WM-10
PDR
(Return to WM, 623-SS)

July 22, 1982

Dr. Robert Wright
U.S. Nuclear Regulatory Commission
M.S. 697 SS
Washington, D.C. 20555

Figure 1. Trilinear plot of lower Saddle Mountains/Wanapum composite and Wanapum wells from RHO reply figures 1 and 3.

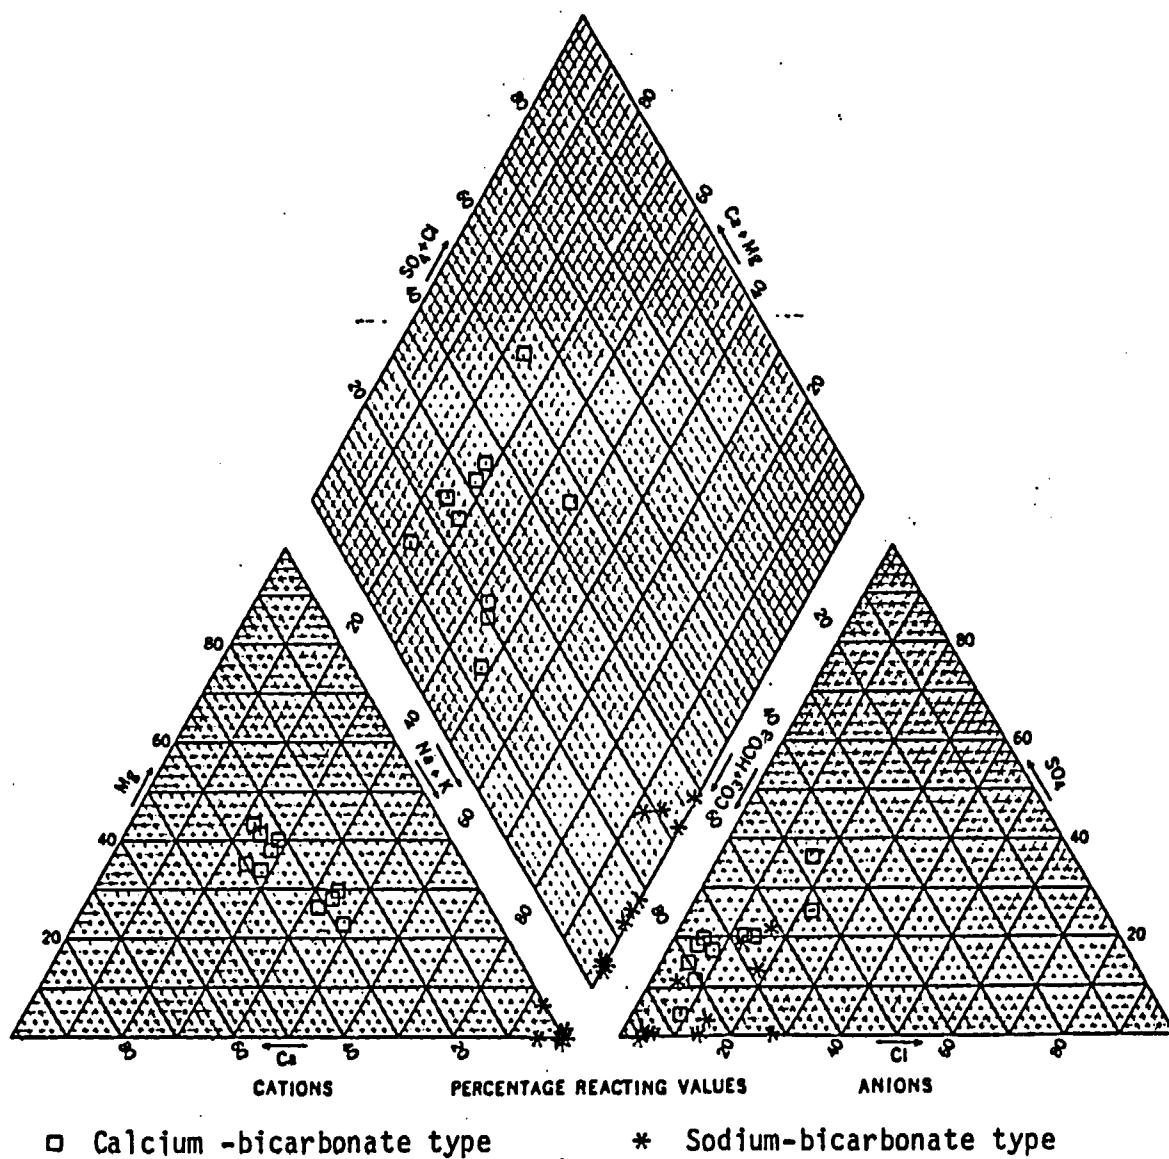
I was particularly intrigued by the here-to-fore unavailable data that was included in the Rockwell reply. If our mixing hypothesis is correct, the "new" data taken from the Pasco Basin area should support this premise. As a test, I have plotted the "new" data on Piper trilinear diagrams. Figure 1 plots only the wells RHO designates as 1) composite - lower Saddle Mountains/Wanapum (LSM/WP) and 2) Wanapum (WP). This plot illustrates the distribution of water within one hydrostratigraphic interval. According to RHO, this should be one water type only.

From Figure 1, it can be seen that the (LSM/WP) and the (WP) plot as two distinct water types; a Calcium-Bicarbonate type and a Sodium-Bicarbonate type. The areal distribution of these types is shown as Figure 2. As can be seen, the Sodium-Bicarbonate type falls within the central Pasco Basin. The Calcium-Bicarbonate type surrounds this area.

Figure 3. Trilinear plot of all data on RHO reply figures 1 and 3.

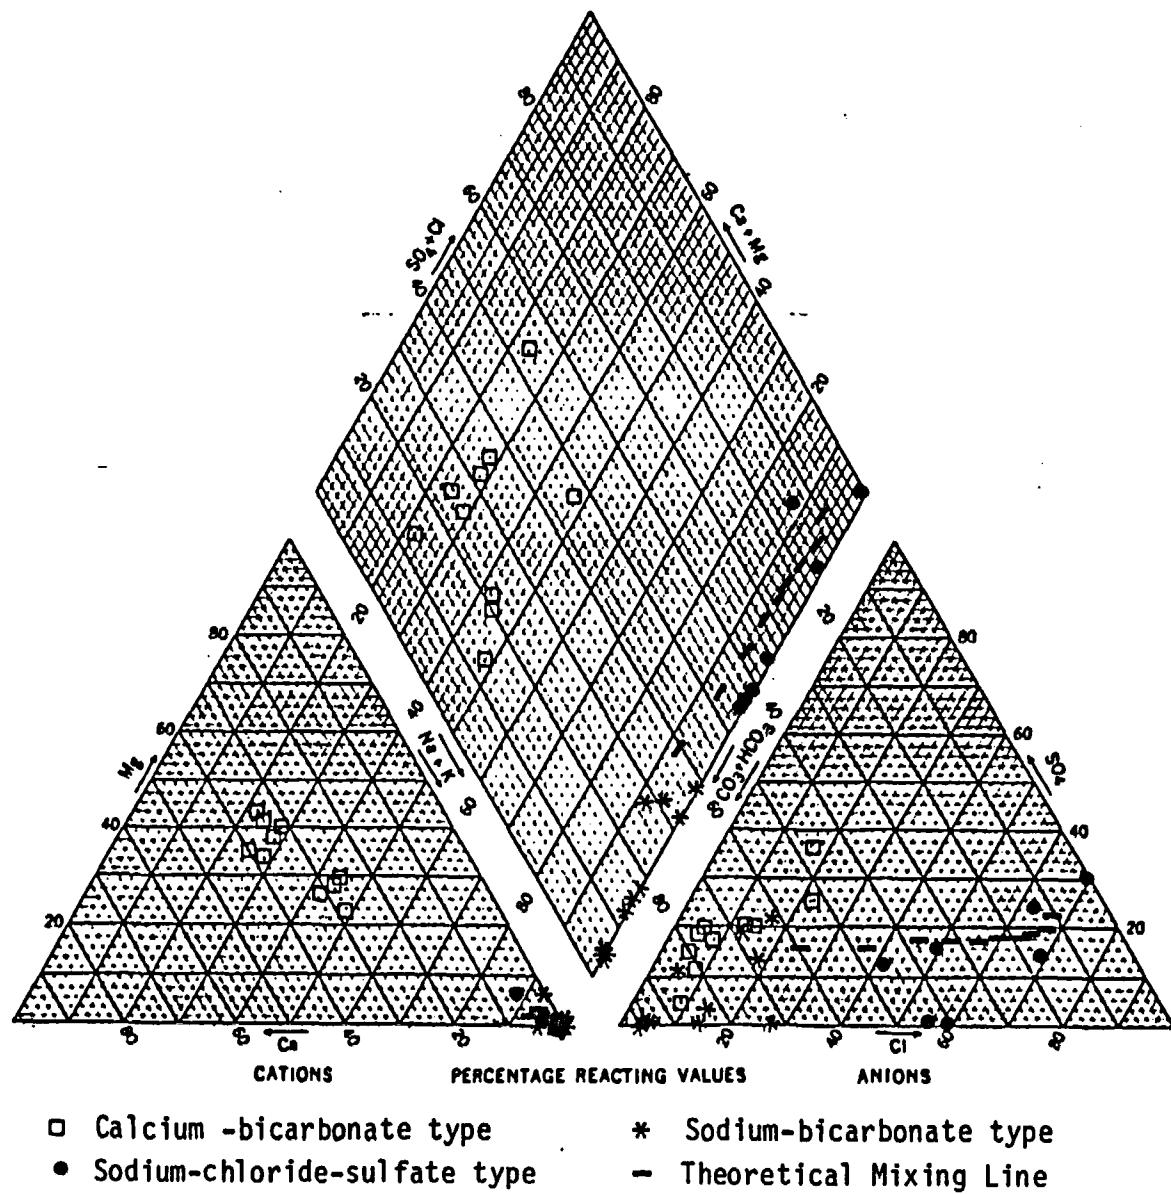
Figure 3 is a plot of all data from Figures 1 and 3 of the Rockwell reply. The additional deep data from the Grande Ronde/Lower Wanapum (GR/LWP) plots as a dominantly Sodium-Chloride-Sulfate type. However, the data points do not tightly cluster as a distinct group, but rather plot on a straight line towards the Sodium-Bicarbonate type. This linear trend is an indicator of mixing between the (GR/LWP) water type and the Sodium-Bicarbonate type within the central Pasco Basin. Notice that no mixing trend is evident between the Calcium-Bicarbonate type and the (GR/LWP) type.

In order to confirm that this mixing trend was real, the USGS water chemistry code "WATMIX" was utilized. This code requires as input, water chemistry from the two types of water that are suspected to be mixing. I used the chemistry data from Well DC-14 (GR) and Well 45 from the geochemistry paper. The WATMIX code calculates theoretical mixing between the two water types. As output, the code will tell you what the theoretical chemical mixture would look like from mixes of 100% DC-14 - 0% Well 45 to 0% DC-14 - 100% Well 45 in 10% increments. This chemistry, when plotted on a trilinear diagram, will

be the line the real data should follow if true mixing is occurring. This theoretical mixing line is plotted as X's on Figure 3. It can be seen that the field data plot exactly along this line.

Figure 4. Trilinear plot of all available data in Pasco Basin area.

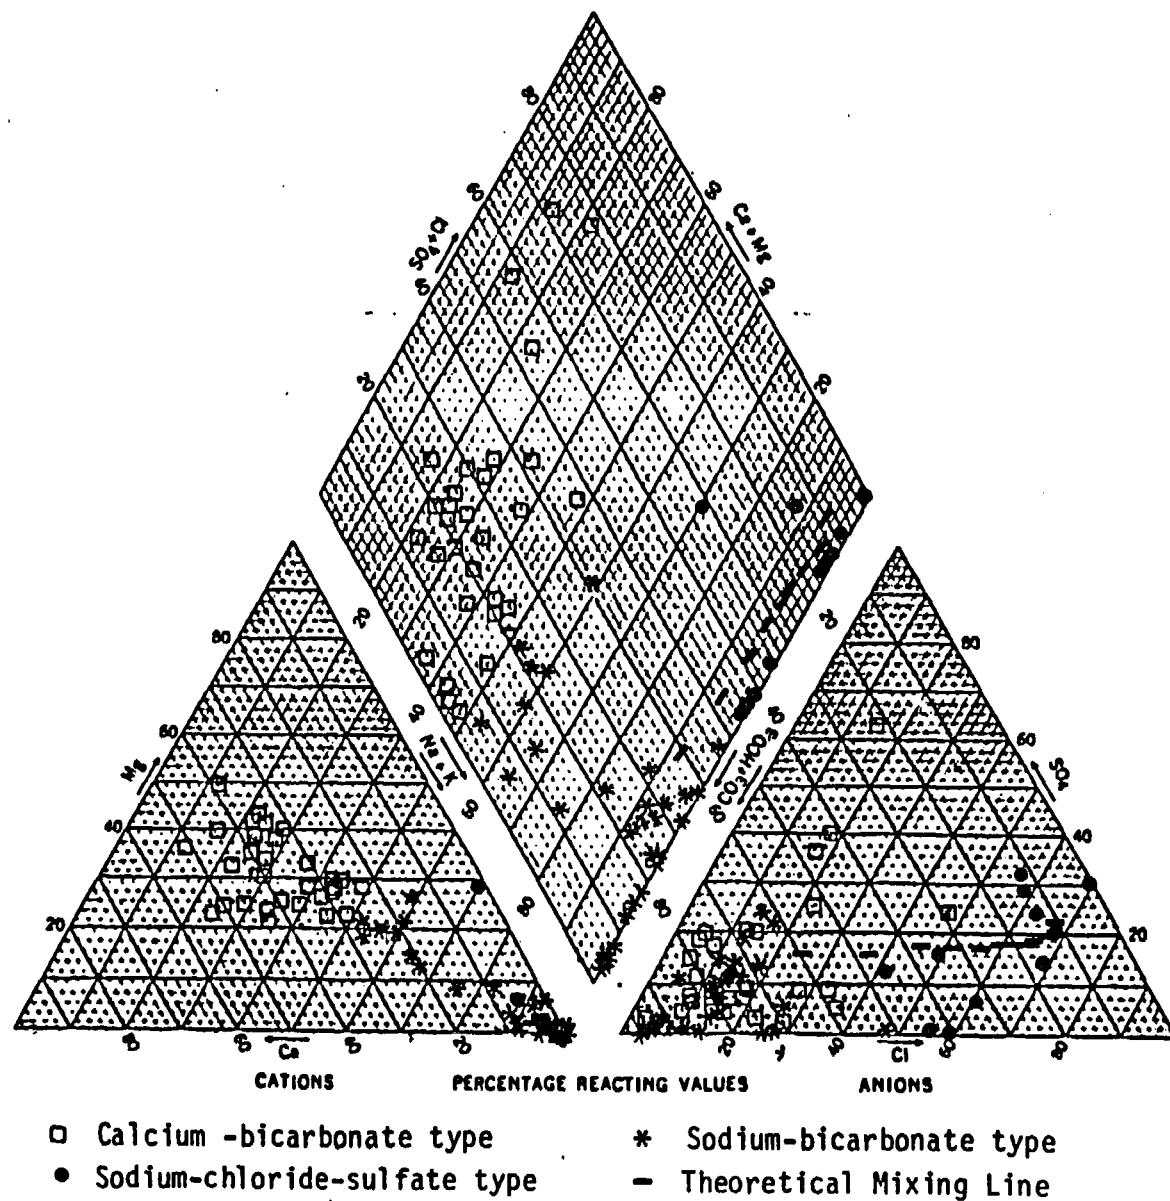
Figure 4 is a plot of all available data (RHO reply plus our geochemistry data appendix) for wells lying in the Pasco Basin and immediately adjacent areas. When plotted, this data indicates an additional mixing trend. That of Sodium-Bicarbonate type water mixing with the Calcium-Bicarbonate type. This trend could be the result of cation exchange of calcium for sodium in clays along the flow path. Due to the completeness of the exchange, however, I believe mixing is more probable. Obviously, some combination of the two is also possible.

Figure 5. Conceptual Geochemical Model.

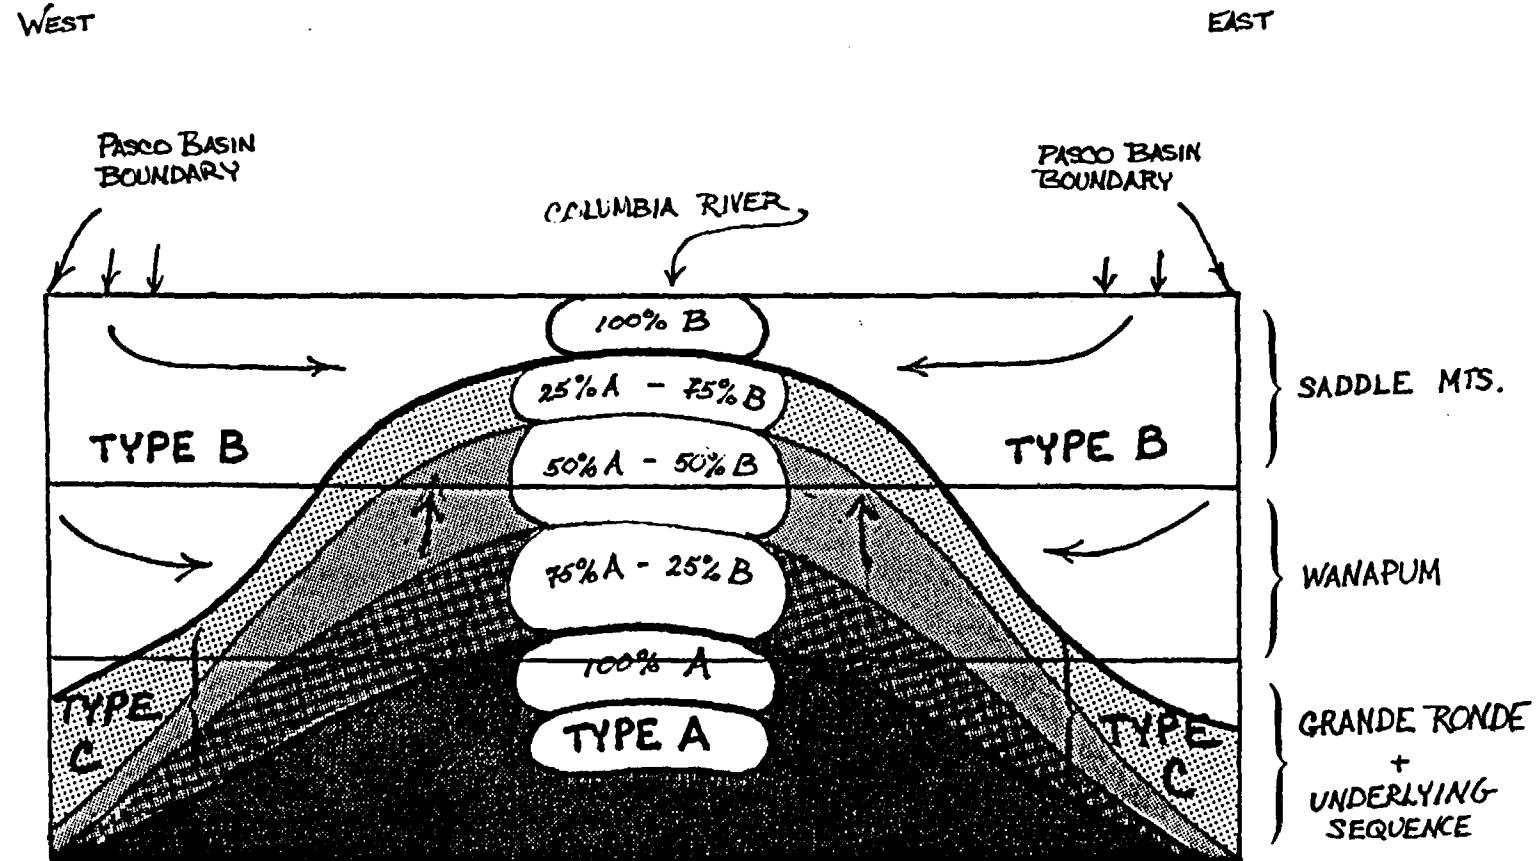
A plausible geochemical conceptual model emerges as a result of these previous four figures; and is shown schematically as Figure 5. For ease of interpretation the water types have been designated as A, B and C. The Calcium-Bicarbonate type is B; the Sodium-Chloride-Sulfate type is A; and the Sodium-Bicarbonate type is C. Figure 5 demonstrates the mixing hypothesis; i.e., A + B → C.

The sodium within the type C water comes from the Sodium-Chloride-Sulfate water type A. The bicarbonate in the type C water comes from the Calcium-Bicarbonate water type B. The type C water is actually a gradual mix of A and B going from 100% A - 0% B to 0% A - 100% B, progressing upward through the geologic section.

FIGURE 1.
SELECTED CHEMICAL QUALITY DIAGRAMS FOR GROUNDWATERS
WITHIN THE PASCO BASIN.

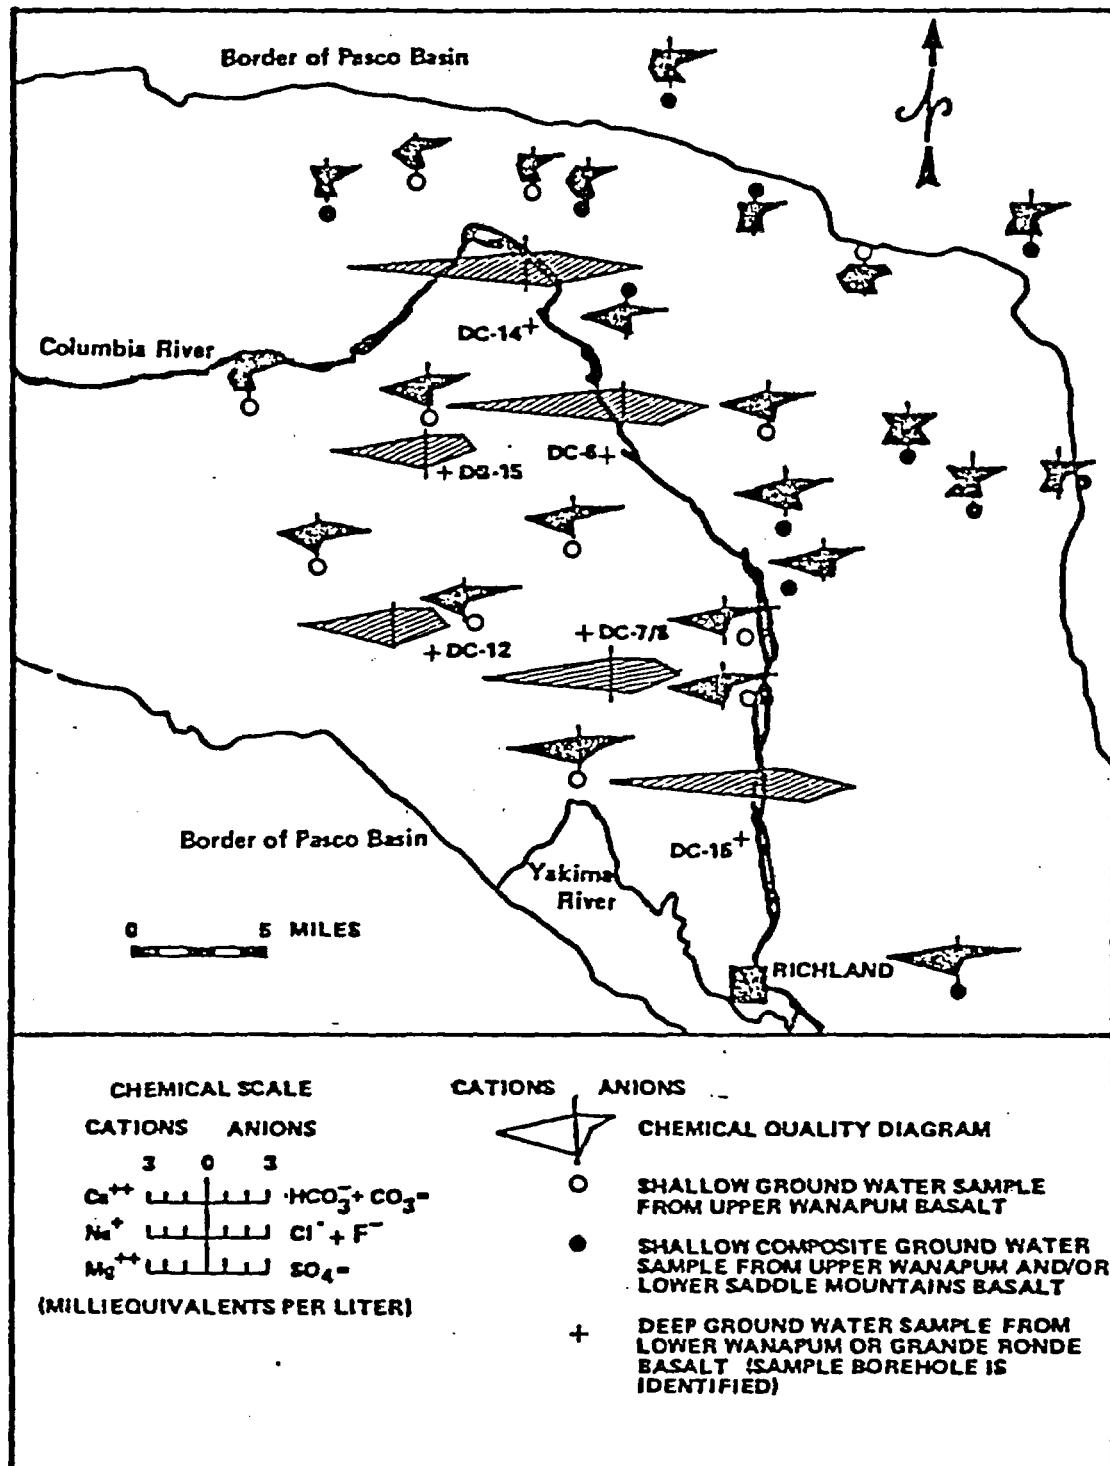
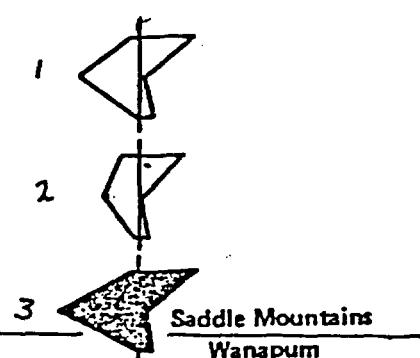
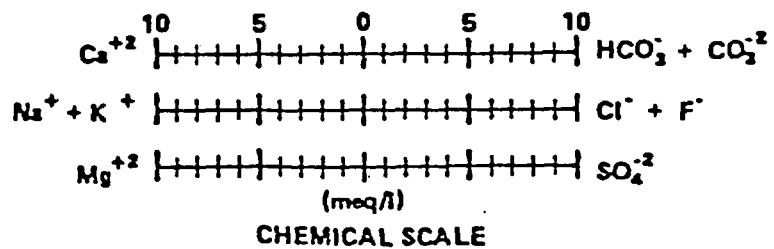
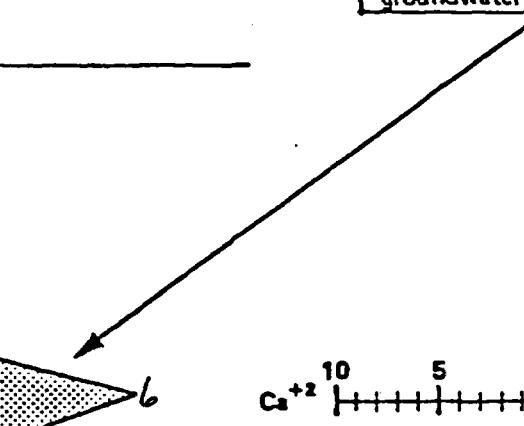
The NRC should have used
these two groundwater samples
for comparison.

The NRC compared these two
groundwater samples.
